# REPORT TO COUNCIL

**Application:** DVP17-0044 DP17-043

**Address:** 4760 Lakeshore Rd

**Subject:** Development Variance Permit and Development Permit Application

Figure 1 – Setbacks of buildings from ALR edge

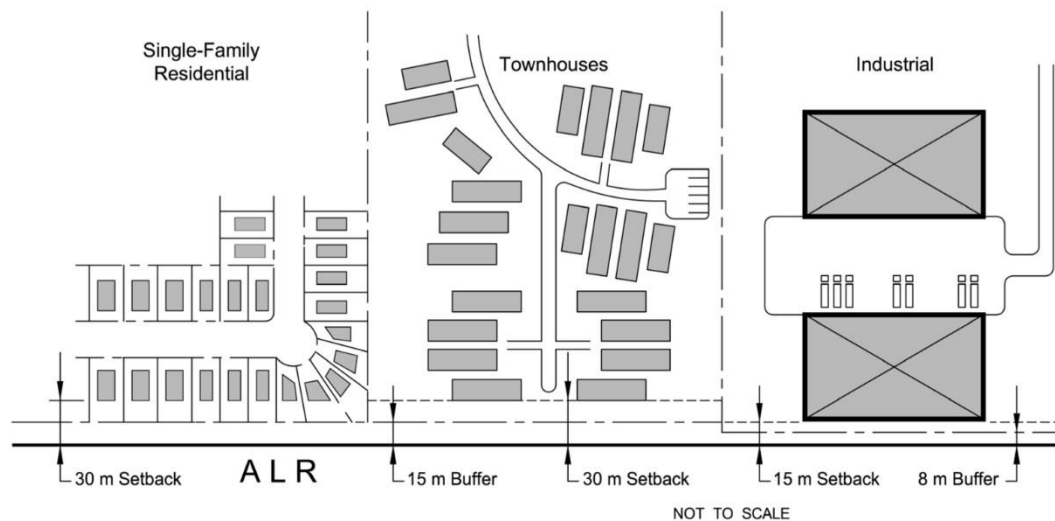
The proposal does not include any further building setback from the 15-metre buffer, which is a recommendation from the Ministry of Agriculture's Guide to Edge Planning. For residential developments, the appropriate setback should be 30.0 metres.
